# **PDX-2000**

## **Modification Manual**

**February 18, 2003**

## **Description:**

Please refer to attached figure #1.

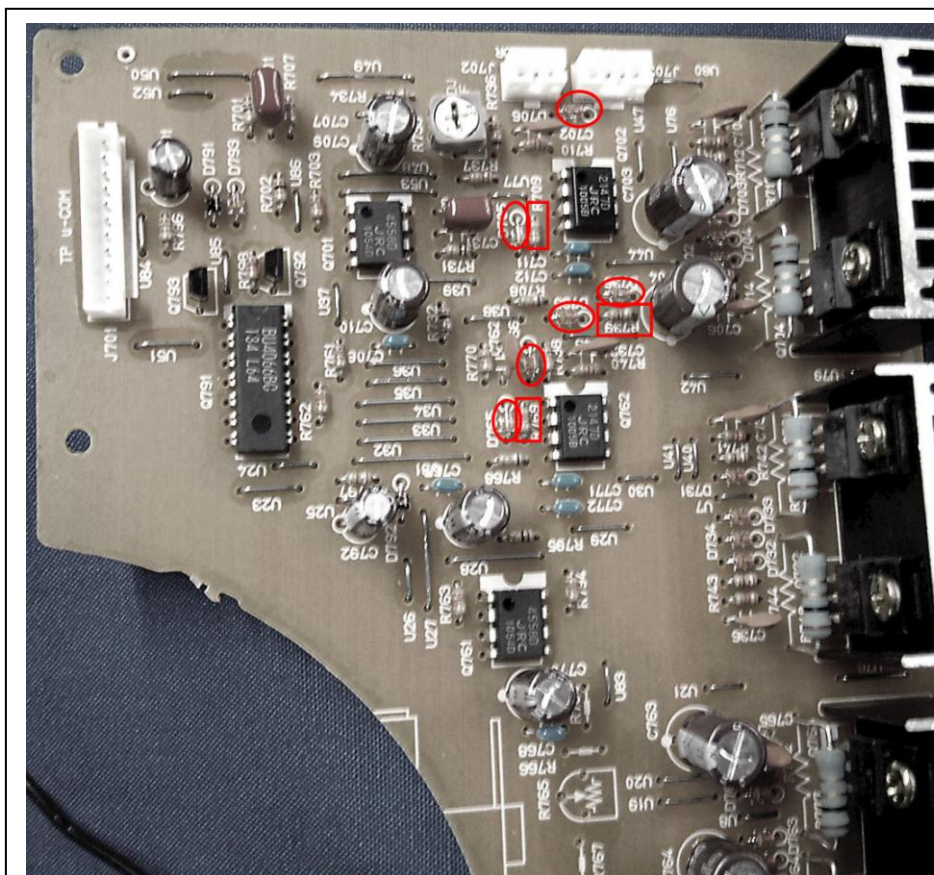
When the platter is pushed down and a fair amount of pressure is applied (during scratch play), the platter may generate a vibration. This problem occurs on units produced in the first few batches.

1. On the main PCB (the largest PCB located besides the motor), remove the following six diodes; D705, D706, D735, D736, D765 and D766.
2. Replace the following resistors (from 820 ohm to 470 ohm); R709, R739 and R769.

**Remove**

D705, D706

D735, D736

D765, D766

**Replace**  
820  $\Omega$  — 470  $\Omega$

R709

R739

R769
